**FINDINGS AND RECOMMENDATION
OFFICE OF PLANNING AND ZONING
ANNE ARUNDEL COUNTY, MARYLAND**

CASE NUMBER: 2024-0205-V

REQUEST

SHEET 1 OF 1
VARIANCE SITE PLAN
ARUNDEL ON THE BAY
 144 Sycamore Ave
 ANNAPOLIS, MD 21403
 PARCEL # 02-002-0477500
 TAX MAP 57 BLOCK 21 PARCEL 15 TAX ACCOUNT # 02-002-0477500 ZONING R2
 SECOND ASSESSMENT DISTRICT AVE. JAMES H. COUNTY, MARYLAND 21403

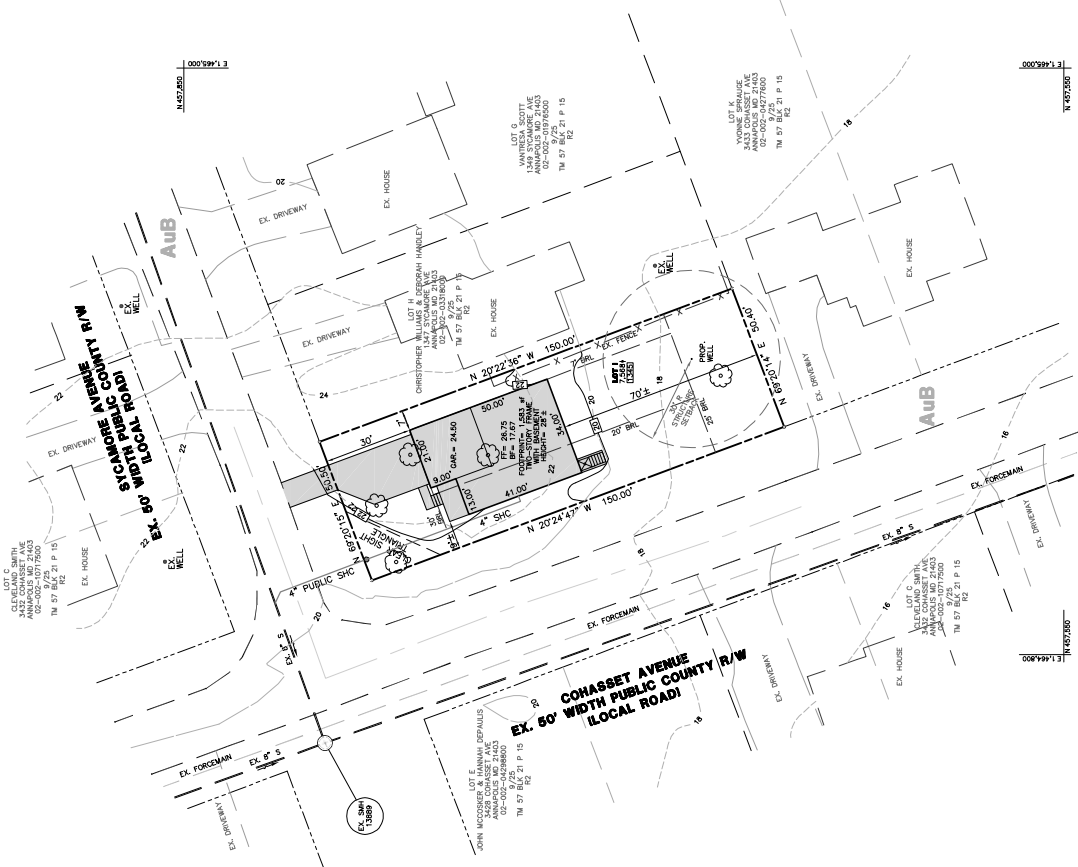
14. There is an existing tree currently shown in the proposed Clear Sight Triangle; however, there is no reference for it to remain or be removed. The other trees on the lot are also not labeled to remain or be removed. The tree sizes and types are also not labeled.

15. If public water is not available, remove the existing and proposed public water meters and existing water line linetype from the Legend.
16. Critical Area Report – Water Quality & Habitat Impact Minimization – It is noted, "...the entire site will be wrapped in silt fence..."; however, silt fence is no longer used in AA Co., Reinforced Silt Fence or Super Silt Fence must be used.

17. Label the size of the existing forcemain in Cohasset Ave. on the Grading Plans. Add the Public Plan Number for the forcemain too.
18. Label the material of existing 8" sewer pipe on the Grading Plans. Add the Public Plan Number for the gravity sewer too.

19. Update the Zoning reference in the Cover Letter to note R2.
20. Label or note on the plan the property is fully within the LDA.
21. Label the tree/shrubs and note their sizes.

22. On the Grading Plans, note when (month and year) the topo was surveyed. If County GIS was used, note what year it was surveyed.
23. It appears the neighbor's fence (1347 Sycamore Ave.) is on this property. An easement will be required during Grading Permit or the fence will need to be relocated. A separate fence permit may be required if it is to be relocated/rebuilt.

26. On the Variance Site Plan, ensure that the square footage of the proposed house on the Impervious Lot Coverage section and on the Plan correspond with each other. If the impervious area includes the rear areaway or the front porch, please note that to prevent confusion.
